Paper Overview

This paper is intended to clarify certain technical points of interest and implementation philosophies. Functional changes have been avoided so that backwards compatibility does not become an issue at this time.

Clarifications

Figure 4.4.1-16-bit Stack Frame on 32-bit Stack

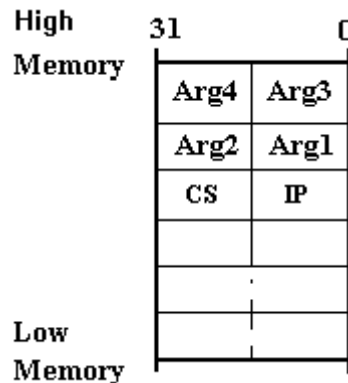
Note: this figure was modified to show where the CS register properly resides in the stack frame.
